TOTEM ACOUSTIQUE INC.

Class II Permissive Change Letter

FCC ID:**2AQ6V-KINAMP**

Please refer to the PCB diagram below.

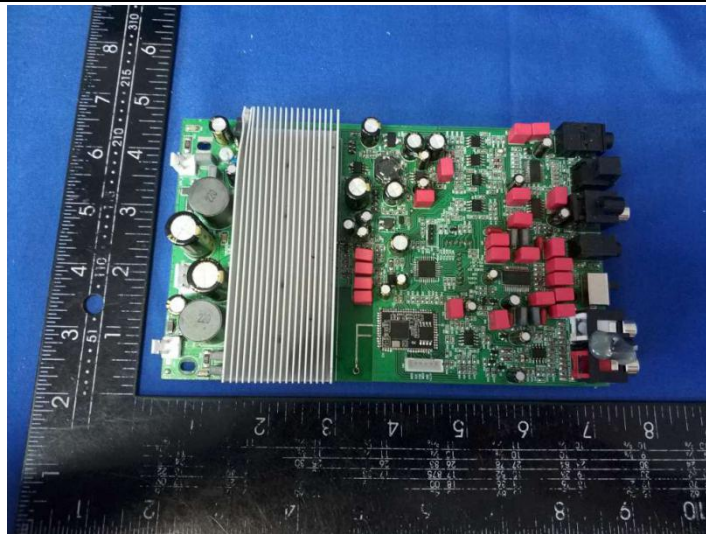
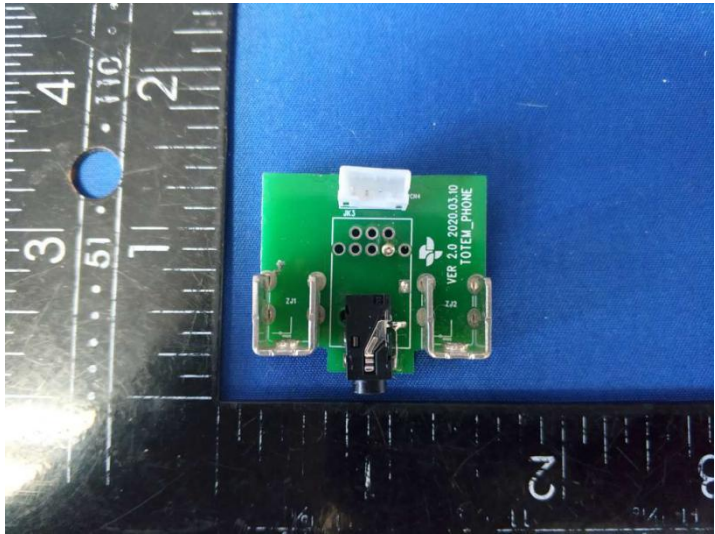
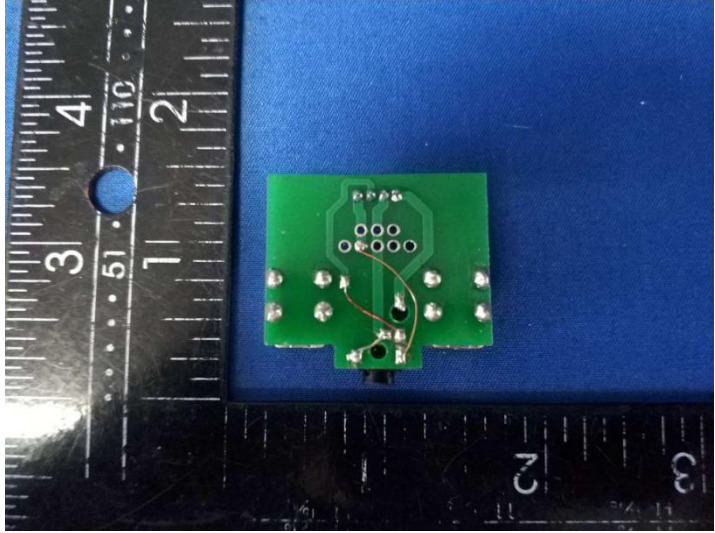
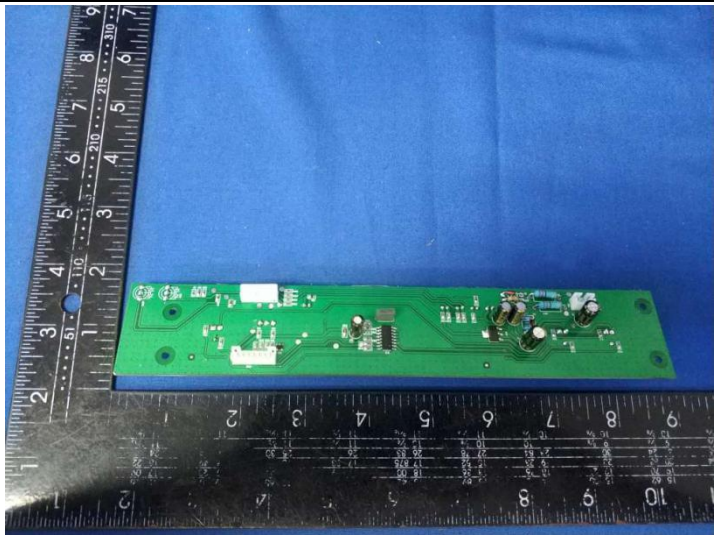
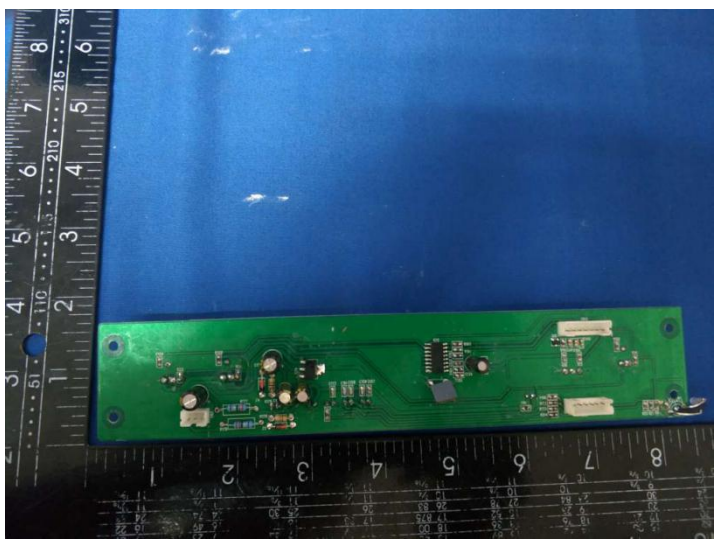
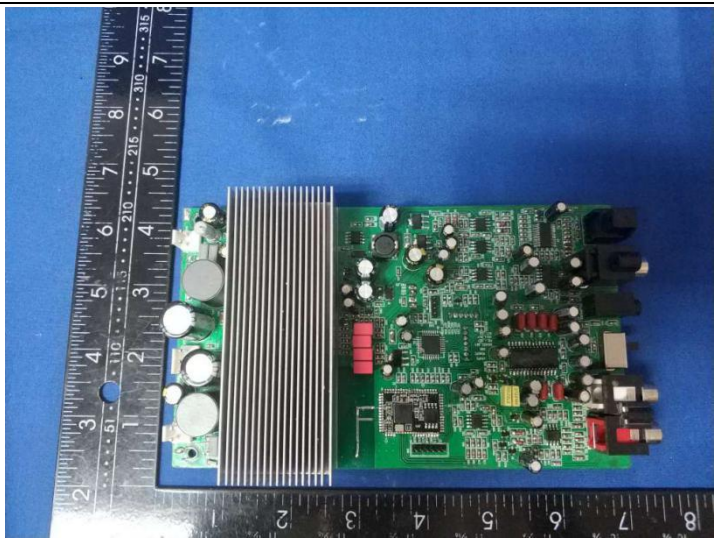
We, the undersigned, hereby attest to the fact that we will apply the class II change. The Bluetooth chip and the transmit antenna remain unchanged and the The major change(s) filed under the application is(are):

Change 1: **Add input port: "Amp in"**

Change 2: **Add output port: "earphone output"**

Change 3: **IC replacement for MCU, Music DETECT, AUDIO PROCESS, SUB OUT.**
